WP-HD6545P

Product Improvement Announcement

Steel Backing Plate

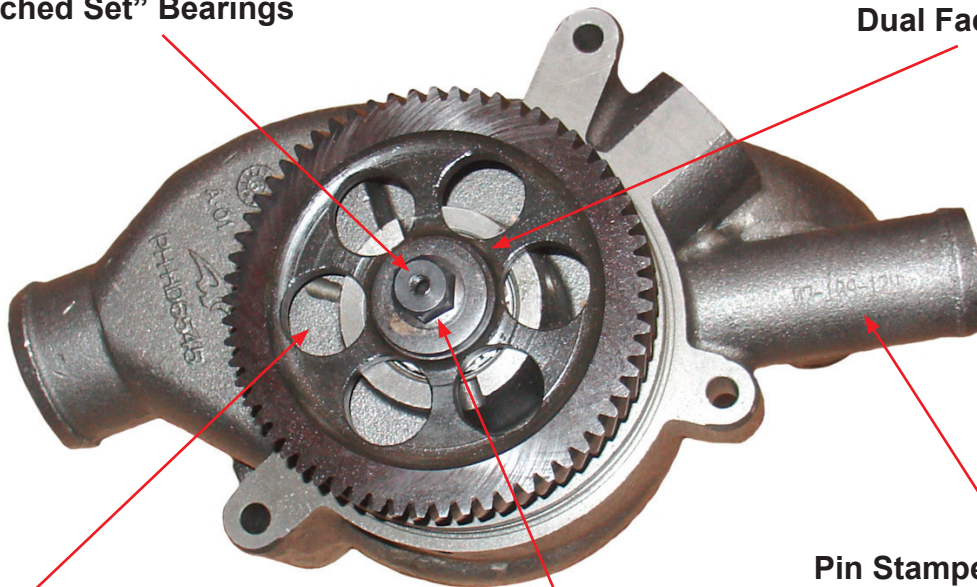
PrimaTech is pleased to announce an important design improvement to the WP-HD6545P Detroit Diesel 60 Series New Water Pump. An enhancement has been made to the OE design, replacing the plastic backing plate with a steel backing plate. The steel backing plate provides longer life and durability as compared to its plastic counterpart that can warp and/or crack with age.
